February 16, 2010

**Comments on the Validation of the Shanghai Caojing
2x1000MW Ultra-Supercritical Project**

On behalf of CDM Watch, the Stanford Environmental Law Clinic respectfully submits the following comment on the Project Design Document (PDD) for the Shanghai Caojing 2x1000MW Ultra-Supercritical Project (Project). We thank the CDM Executive Board and Designated Operating Entity (DOE), Bureau Veritas Certification Holding SAS, for recognizing the integral role of transparency in the CDM validation process, and for taking this comment into consideration.

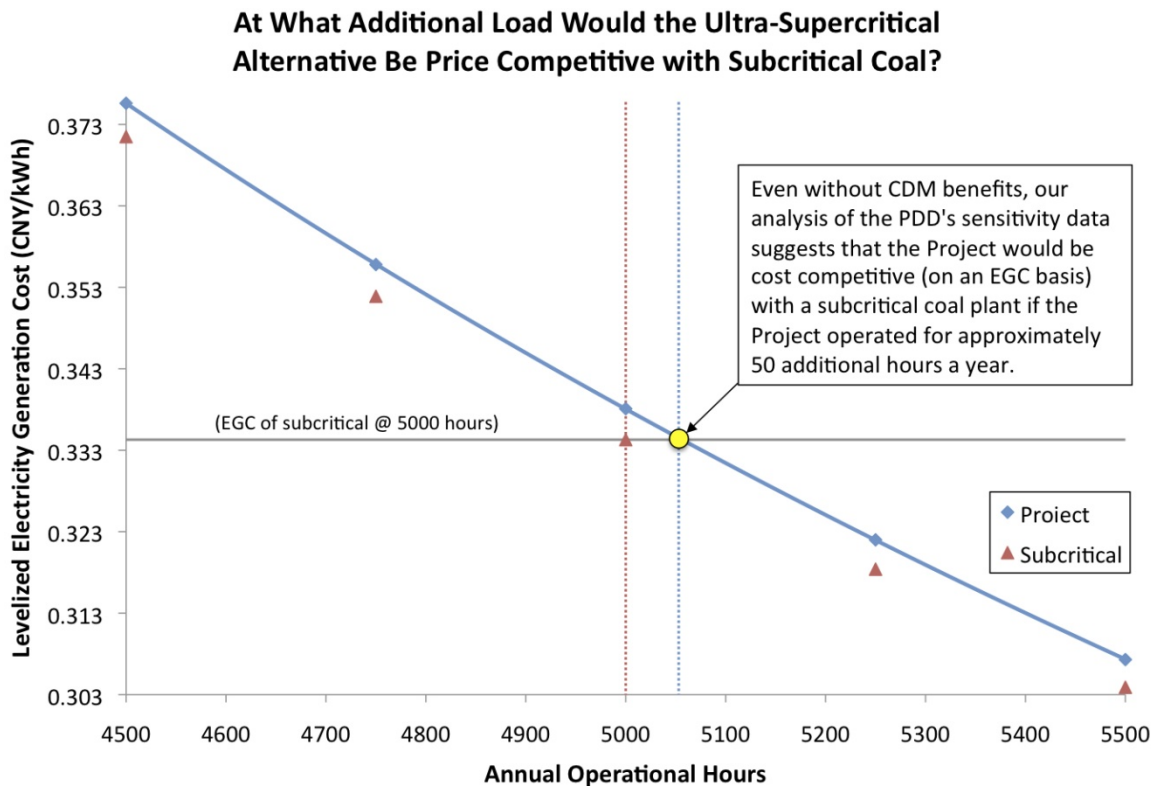
Looking at project participants’ sensitivity analysis, we can see that the ultra-supercritical (Project) alternative would be more financially viable than the subcritical alternative if the ultra-supercritical plant were to operate at a five percent higher load per year.⁵¹ Under China’s dispatch rules, a five percent differential in plant loads could be possible. Furthermore, project participants have considered load sensitivity only in five percent increments, so the PDD does not reveal the exact loading differential needed to achieve price competitiveness between the alternatives.

Our further analysis, based on the PDD’s sensitivity data, suggests that cost competitiveness could actually be achieved at a load differential of only one percent. As shown in the figure below, the ultra-supercritical plant would only need to operate for about 50 more hours (i.e., one percent of the assumed load of 5000 hours) a year to be cost competitive with the subcritical plant. This differential is possible and perhaps probable under China’s dispatch rules. The DOE must challenge project participants’ assumptions regarding plant loads.
